OIL BREATHER

The oil breather code 17 15 57 50 appearing in the parts catalogues for the 850 T3 (and different versions) - V 1000 I CONVERT - V 1000 G5 - 1000 SP, table 2 - position 3, has been cancelled and replaced with the new type code 17 15 57 51.

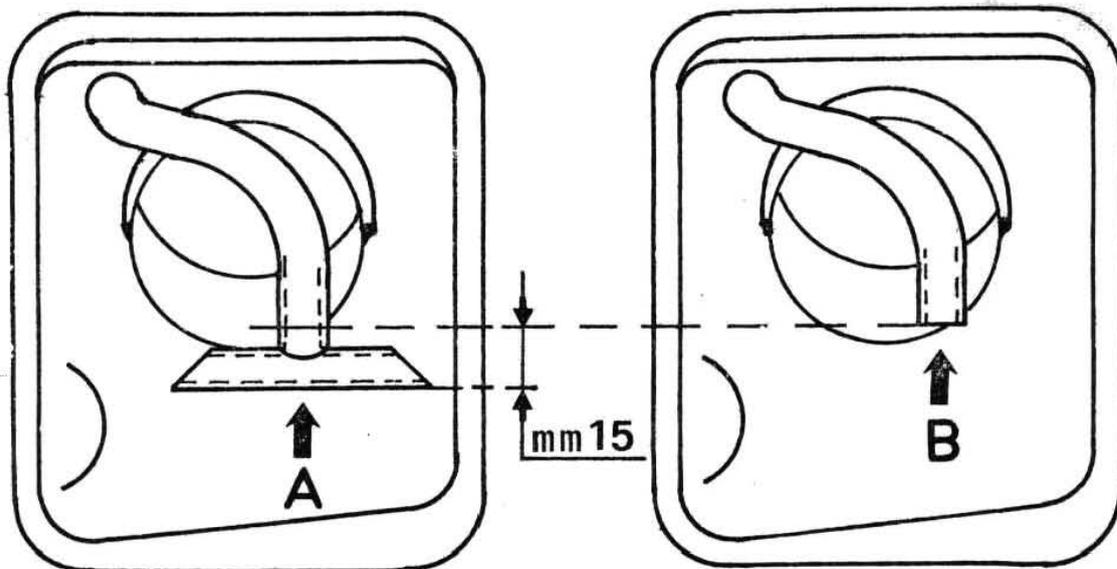
The modification has been made to improve the operation of the oil breather unit; we suggest to carry out the same modification also on the motorcycles previously produced, acting as follows:

- remove the air filter unit from the bike and take out the breather from the intake manifold;
- cut the "T" end (see "A") of the breather tube according to the dimensions (see "B") indicated in the drawing;
- when this has been done, clean everything with gasoline and dry with compressed air. Reassemble the breather and air filter in the manifold.
